#### **Addendum 128 – UN Regulation No. 129**

#### **Amendment 10**

#### **Uniform provisions concerning the approval of Enhanced Child Restraint Systems used on board of motor vehicles**

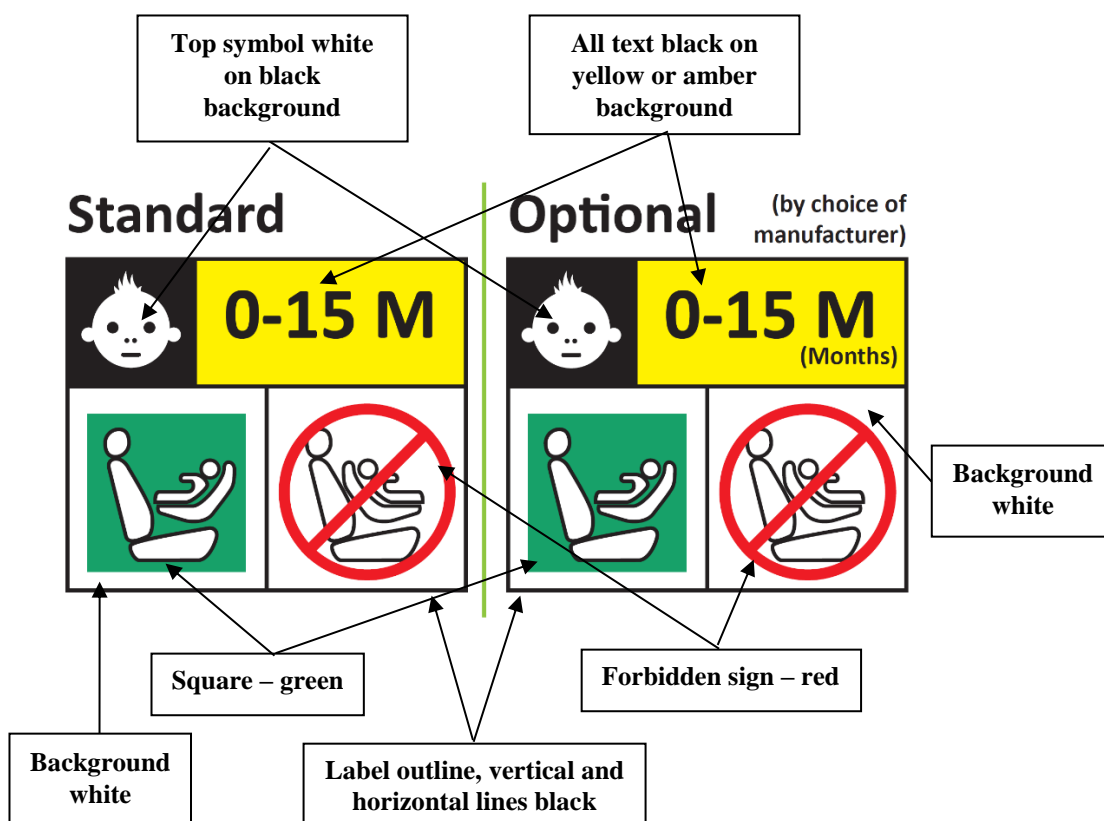
Paragraph 4.5., amend to read:

"4.5. Integral Enhanced Child Restraint Systems that can be used forward and rearward facing, shall have the following label permanently attached on the part hosting the child and visible to the person installing an Enhanced Child Restraint System in the vehicle:

The manufacturer shall be permitted to include the word "months" to explain the symbol "M" in the label. The word "months" should be in a language commonly spoken in the country or countries where the product is sold. More than one language is allowed.

Minimum label size 40 x 40 mm

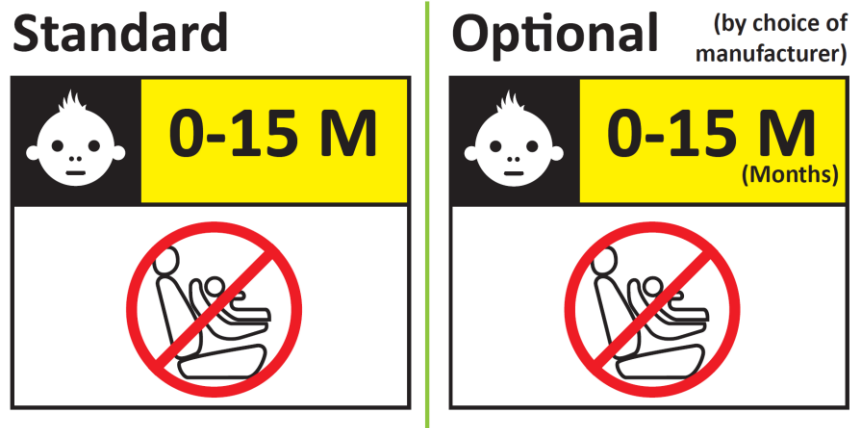
Integral Enhanced Child Restraint Systems that can be used forward facing only shall have the following label permanently attached on the part hosting the child and visible to the person installing an Enhanced Child Restraint System in the vehicle:

The manufacturer shall be permitted to include the word "months" to explain the symbol "M" in the label. The word "months" should be in a language commonly spoken in the country or countries where the product is sold. More than one language is allowed.

Minimum label size 40 x 40 mm
